Re: 750 Marlborough Avenue Warehouse Initial Study and Draft Mitigated Negative Declaration

**Mitigated Negative Declaration (MND) for the
Proposed Guthrie Industrial Warehouse
(Planning Cases P17-0506 (DR), P17-0507 (GE), P17-0748 (GE), and P17-0749 (VR))**

Response to Comments on the Draft IS-MND

Enclosures – Exhibits A- 1 through A-8

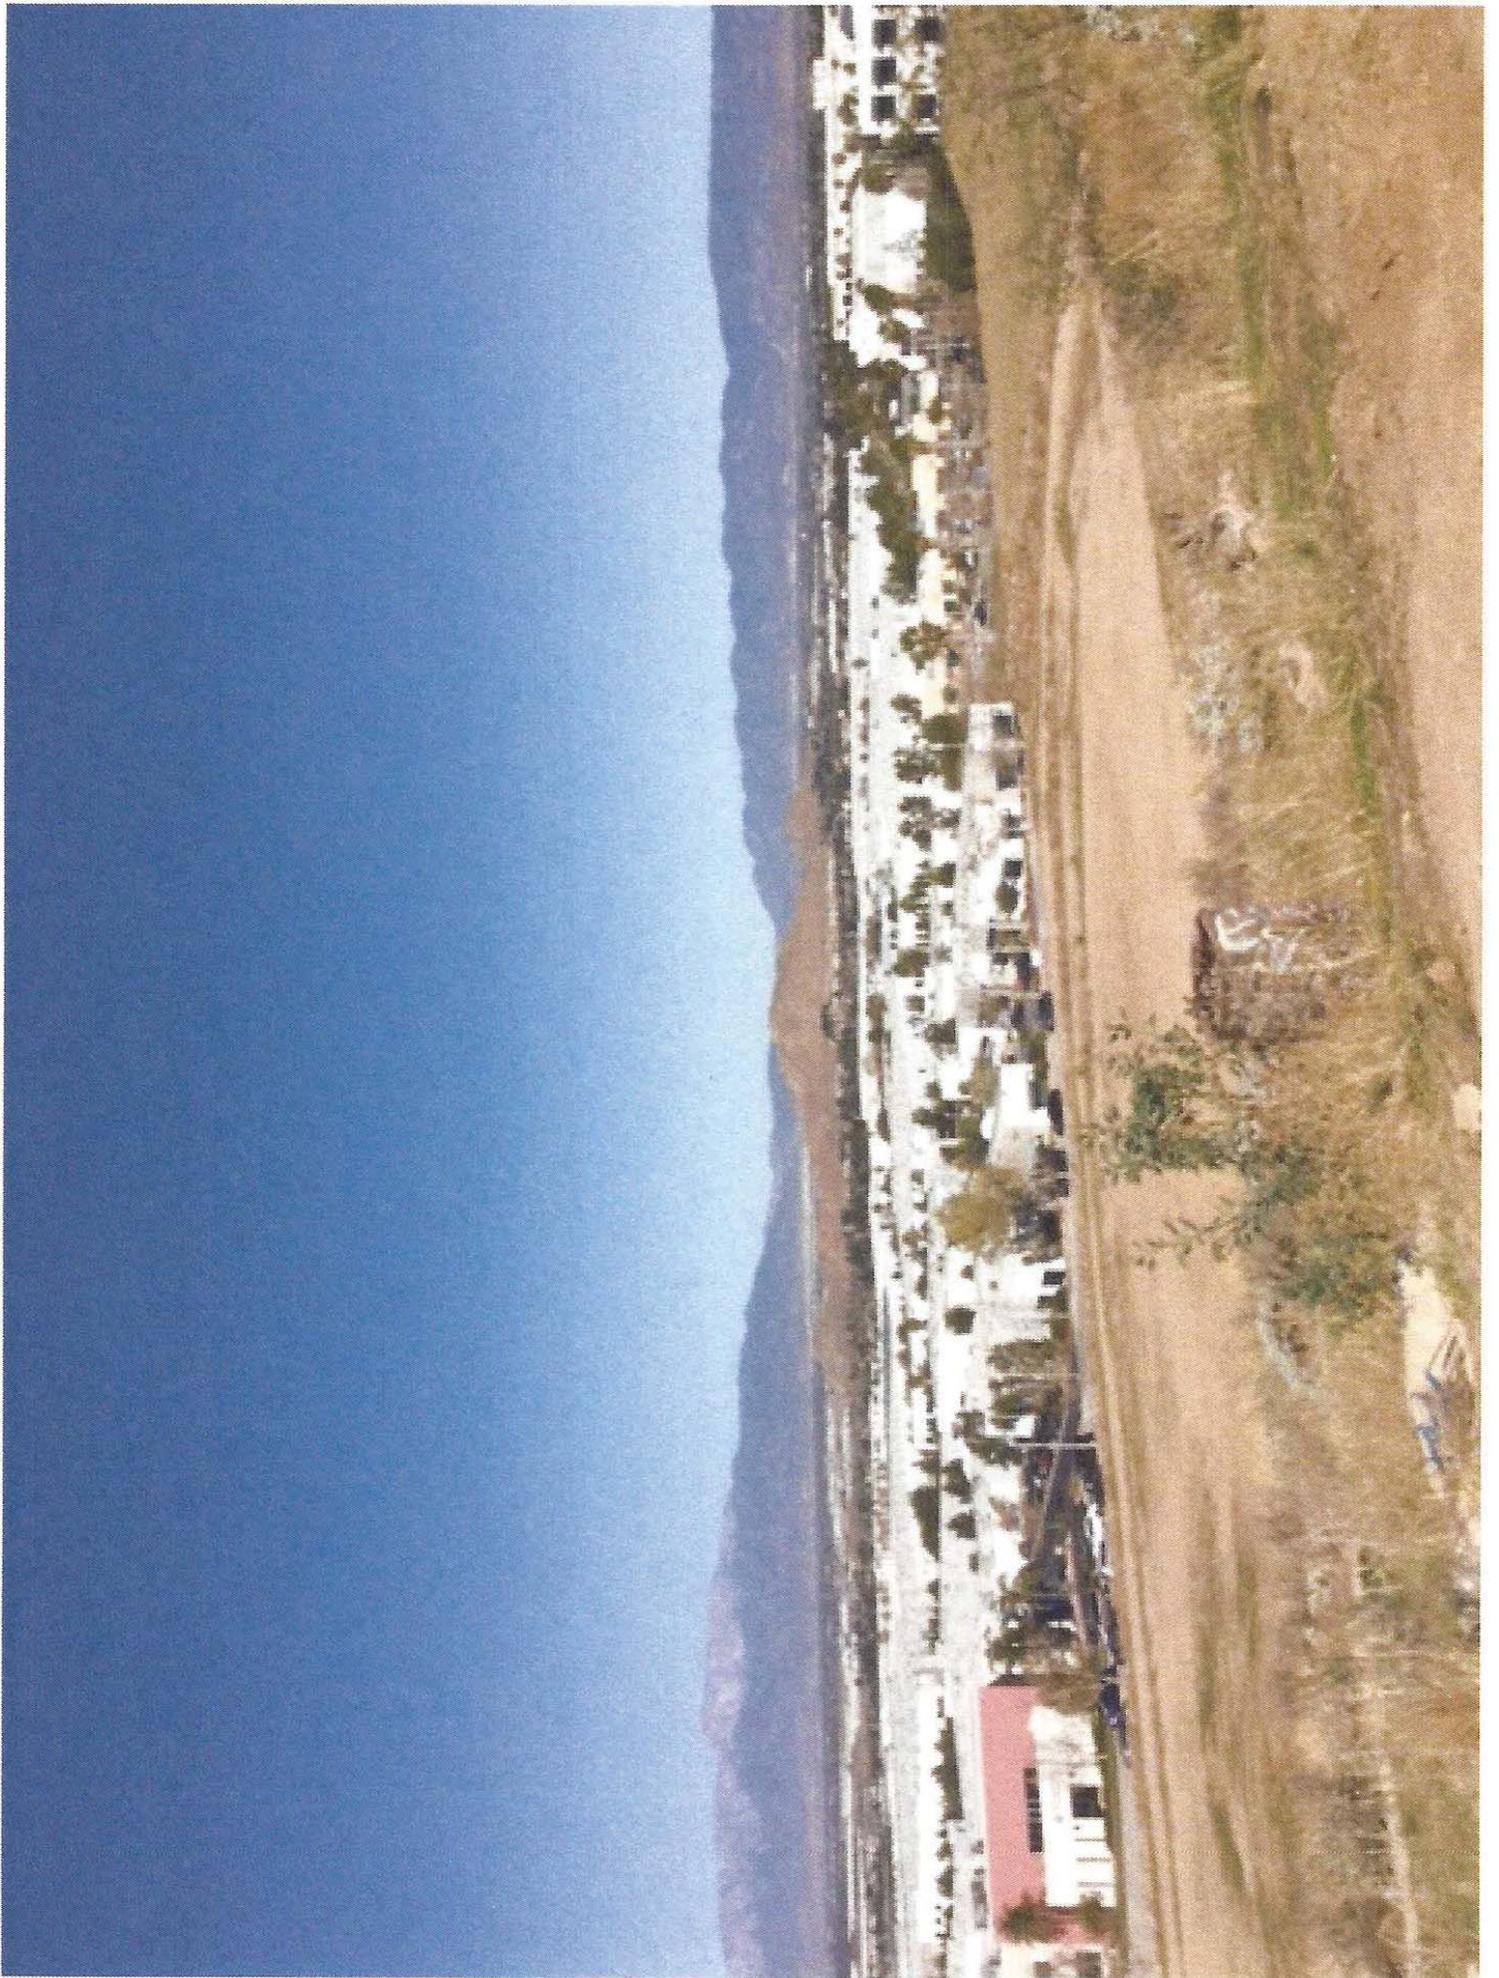
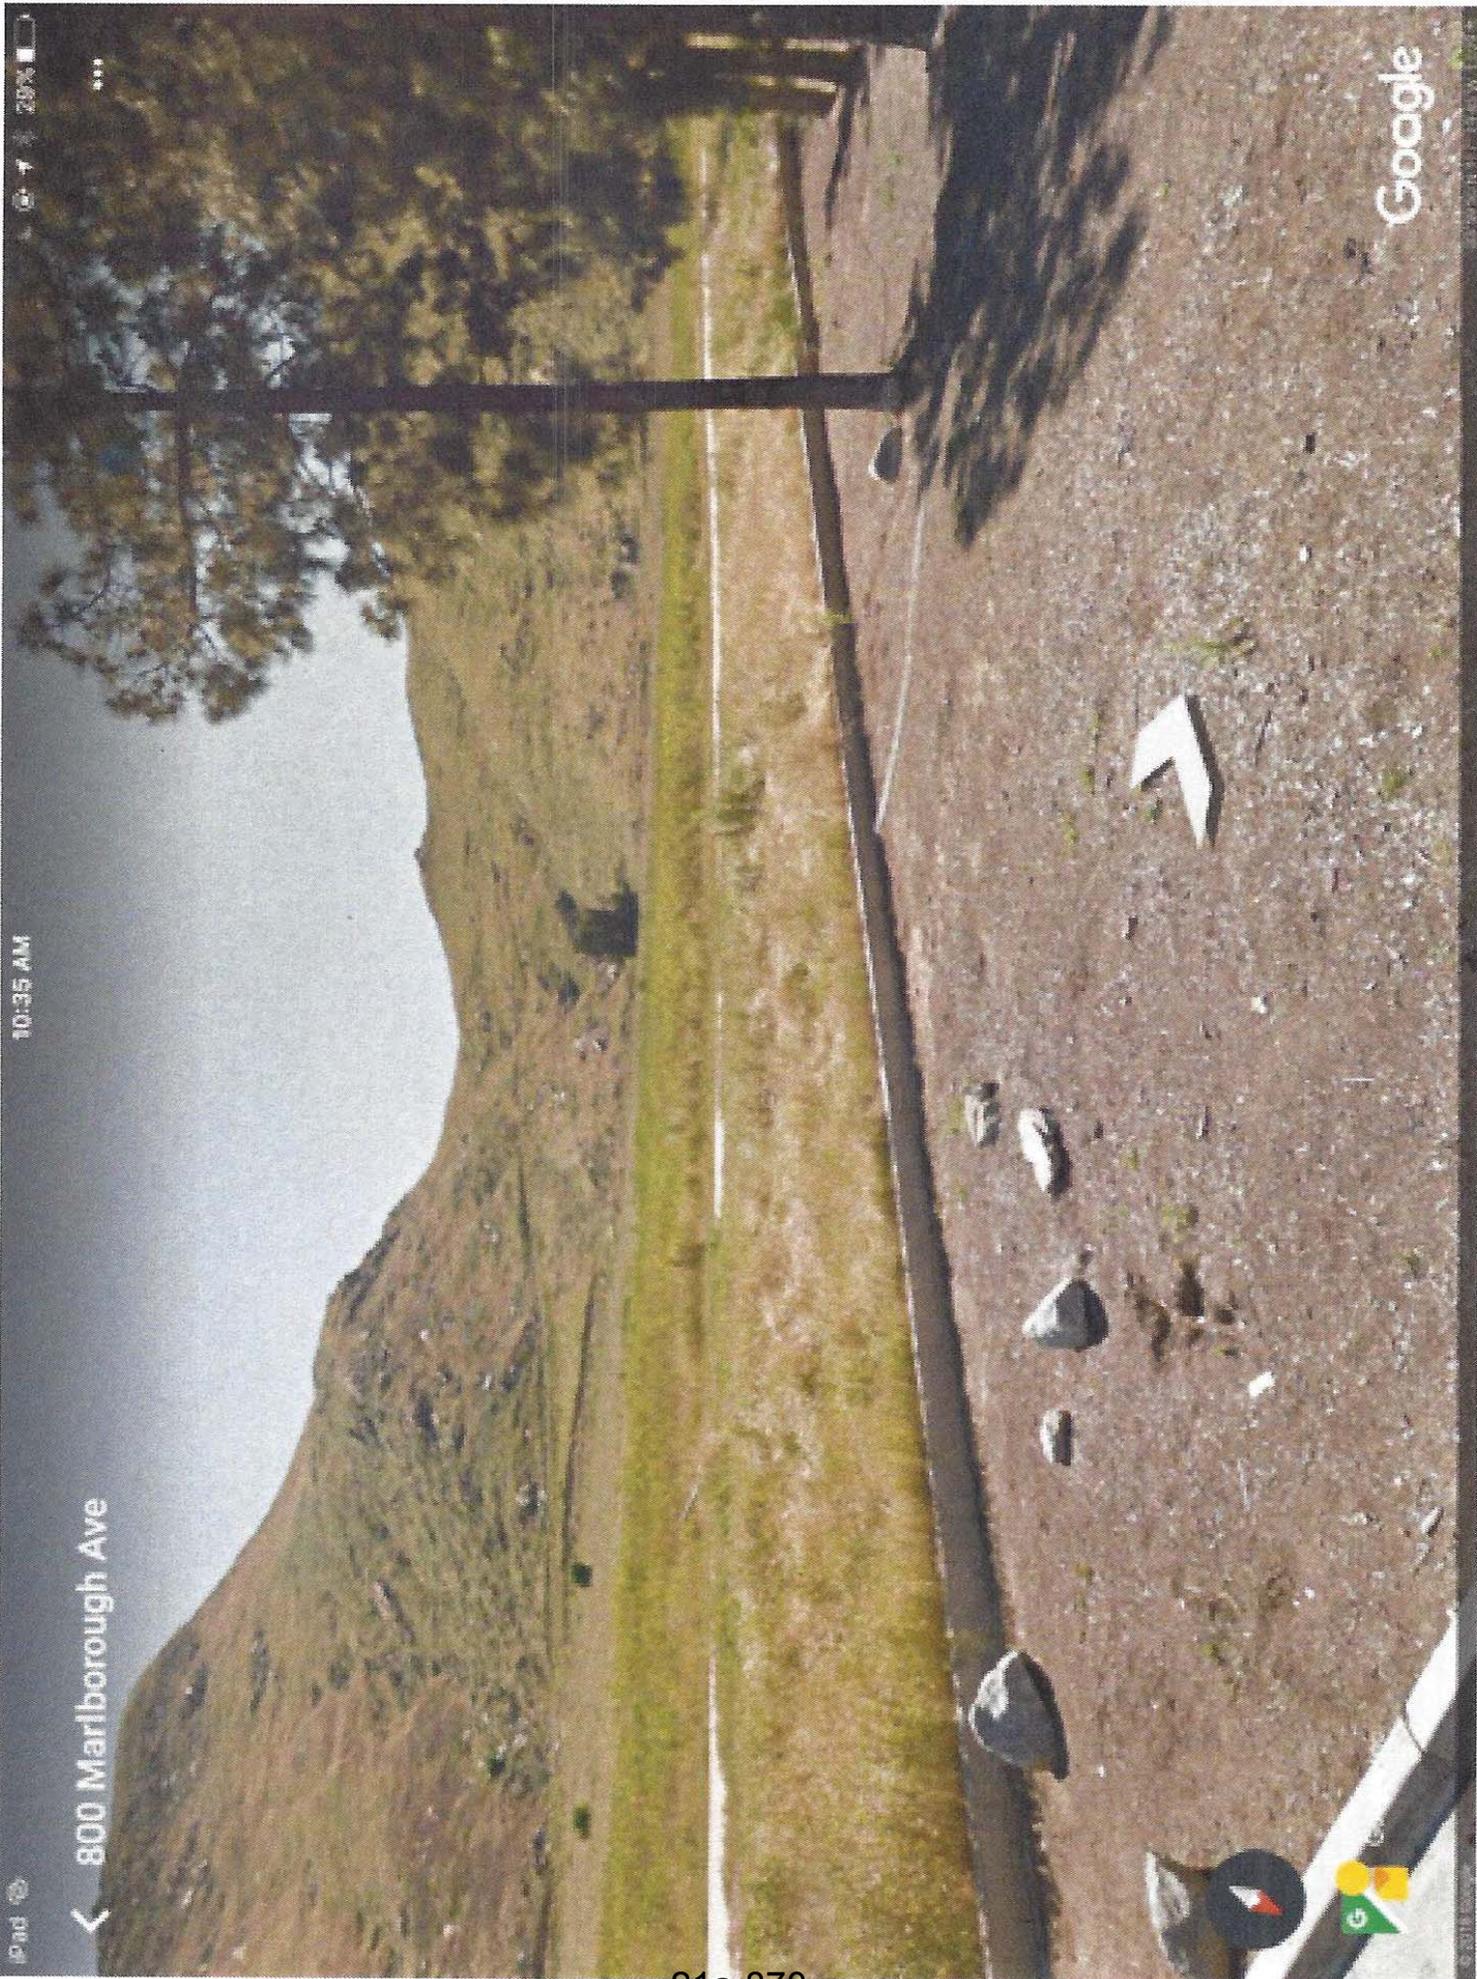
As for aesthetics, the views both of the Reserve and from the trails that lead to the Reserve will be permanently and adversely impacted by the Project's massive height (45') and size (340,000 sf). Exhibits A-1 and A-2 show the views from the bottom of the trail leading across the north side of the Project site to Marlborough Road. Views from this trail to the mountains far to the west are clear and will obviously be blocked entirely by the 45 foot-high warehouse.

Exhibits A-3 and A-4 show the views from the same location as in A-1 and A-2, but looking towards the San Bernardino Mountains. Again, these are incredible views, and part of the value of the Reserve as open space.

Therefore, the shabby analysis claiming there are no significant impacts to aesthetics due to the Project is simply untrue. These photos provide evidence of the impacts, and the 45 foot-high warehouse, the massive parking areas and loading docks, will have an adverse impact on the views of the Reserve and from the Reserve, which impacts cannot be mitigated to a level of insignificance.
